#### **Addendum 73 – UN Regulation No. 74**

#### **Revision 2 - Amendment 7**

#### **Uniform provisions concerning the approval of category L<sub>1</sub> vehicles with regard to the installation of lighting and light-signalling devices**

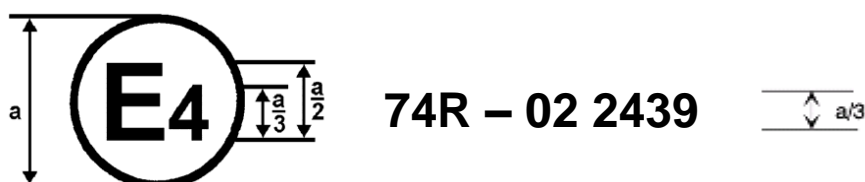
Insert a new item 5.12. and a new footnote 5, to read:

- "5.12. Lamps approved for and equipped with LED substitute light source(s) are allowed to be installed on this vehicle type: yes/no<sup>2,5</sup>

.....  
<sup>5</sup> If yes, list the applicable lamps."
